Appendix I of RNTPC
Paper No. A/YL-KTN/761D

**APPLICATION FOR PERMISSION
UNDER SECTION 16 OF
THE TOWN PLANNING ORDINANCE
(CAP.131)**

Application No. 申請編號	(For Official Use Only) (請勿填寫此欄)		
Location/address 位置/地址	LOT 624 & 787 IN D.D.110 AND ADJOINING GOVERNMENT LAND, KAM TIN ROAD, SHEK KONG SAN TSUEN, YUEN LONG		
Site area 地盤面積	4000.4	sq. m 平方米	<input checked="" type="checkbox"/> About 約
	(includes Government land of 包括政府土地	908	sq. m 平方米 <input checked="" type="checkbox"/> About 約)
Plan 圖則	APPROVED KAM TIN NORTH OUTLINE ZONING PLAN NO. S/YL-KTN/9		
Zoning 地帶	RESIDENTIAL (GROUP C)2 & RESIDENTIAL (GROUP D)		
Applied use/ development 申請用途/發展	PROPOSED RESIDENTIAL DEVELOPMENT (HOUSES)

Re: Response to Departments' Comments
Proposed Private Residential Development at
Lot 624 & 787 in D.D.110 and Adjoining Government Land, Kam Tin Road
Shek Kong San Tsuen, Yuen Long.

FIGURE NO.: 2.2
PROJECT TITLE: Proposed Private Residential Development At Lot No. 624 & 787 in d.d. 110 and Adjoining Government Land, Kam Tin Road, Shek Kong San Tsuen, Yuen Long, New Territories

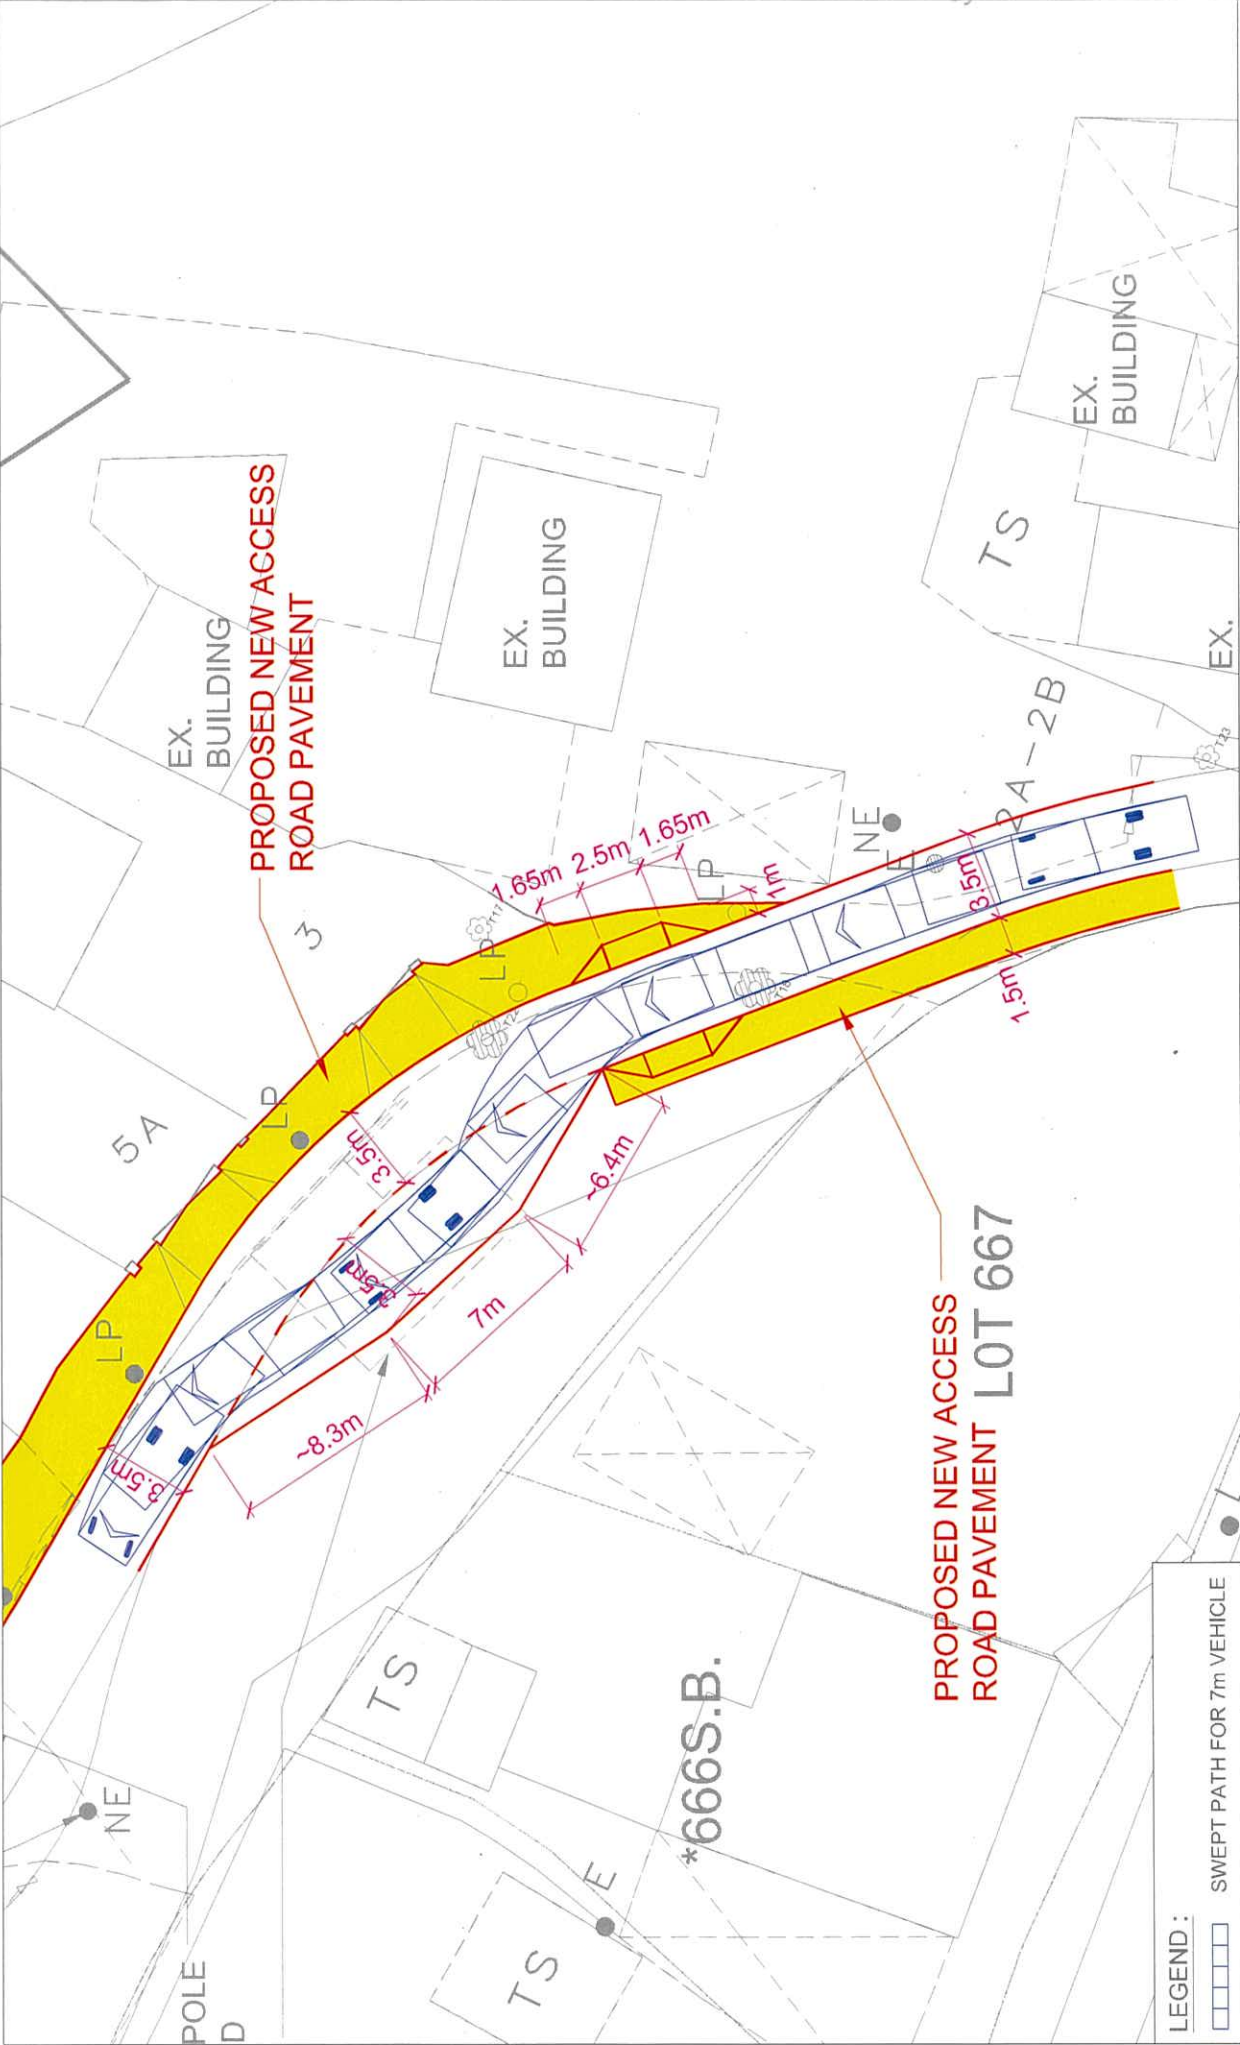
(b) Please clarify if the proposed passing bay is sufficient for refuge of appropriate vehicle length.	<p>As 7m LGV loading/unloading space is proposed to be provided in the proposed development, the longest vehicle using the proposed new access road is 7m LGV.</p> <p>Please find attached drawing (i.e. Figure 2.2 in Appendix B) showing the swept path analysis of 7m vehicle moving in/out at the proposed passing bay for your information. It is demonstrated from the result of the swept path analysis that the proposed passing bay is adequate and sufficient for refuge of 7m vehicle without blocking the opposite traffic.</p>
